Preliminary Comments on the Mill Point Concept Major Site Plan and Major Subdivision Concept Plan

Re: Mill Point Concept Major Site Plan / 49 Bridge Street

Environmental and Site Constraints Findings

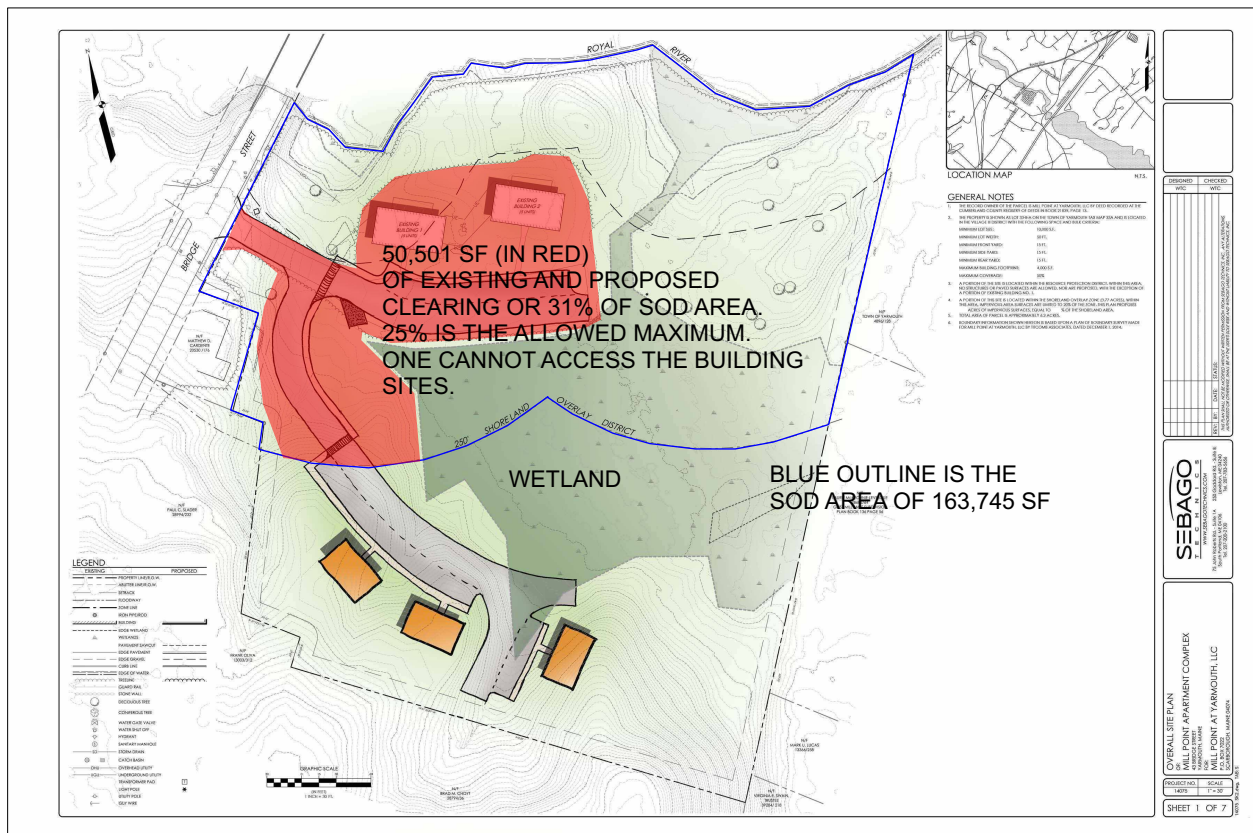
80% of the parcel to the south of the existing development is severely constrained by mapped wetlands, intermittent streams, and erodible 20% to 50% steep slopes. There are two relatively flat knolls to the far southern portion of the site, but these small areas are inaccessible, isolated, and undevelopable due to wetlands, steep slopes, and lack of street frontage. As stated by the Cumberland Country Soil Survey, in no uncertain terms, the only appropriate use for sites with the mapped soil type pf SuE2 is woodland. Developing a site for housing with such extensive mapped wetlands and mapped erodible soils is reckless, against code, and contrary to all environmental best practices for site development.

7. Conflict with the Comprehensive Plan

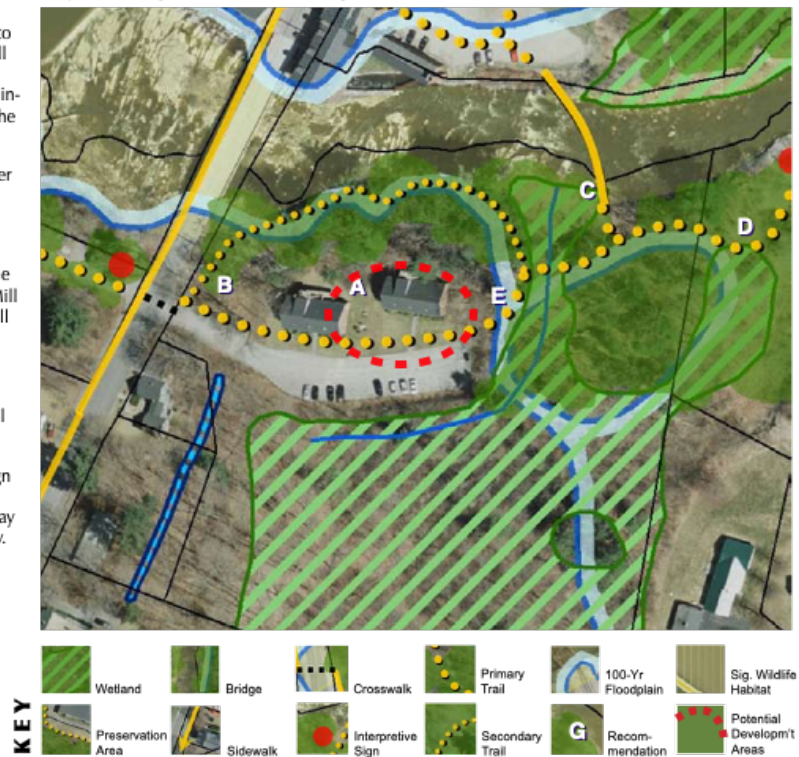
The Royal River Corridor Master Plan from 1.30.09 is adopted by the Town as part of the Comprehensive Plan. The Planning Board must reference the Comprehensive Plan for guidance when it comes to reviewing the Concept Plan. The Master Plan specifically looks at the Mill Point site and expressly states that any future development should occur adjacent to the existing apartments. The rest of the site has extensive wetlands and steep slopes considered by the Comprehensive Plan document as infeasible to develop as called for in the Concept Plan.

12. MILL POINT APARTMENTS

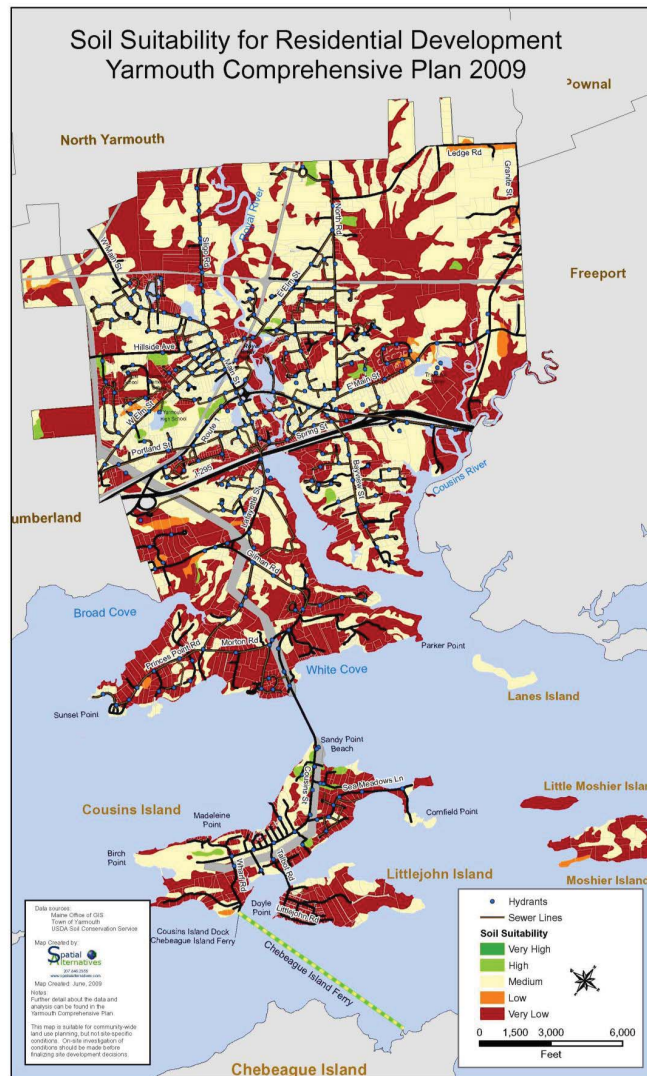
The Comprehensive Plan also includes a map called Soil Suitability for Residential Development and the project site is mapped as Very Low Suitability for Residential Development:

The Mill Point site was carefully considered during the master planning process and development was only recommended in a small window of an area by the existing apartments and the document specifically states. “A large piece of undeveloped land west of the apartments is quite steep and wet and may not allow significant expansion.”
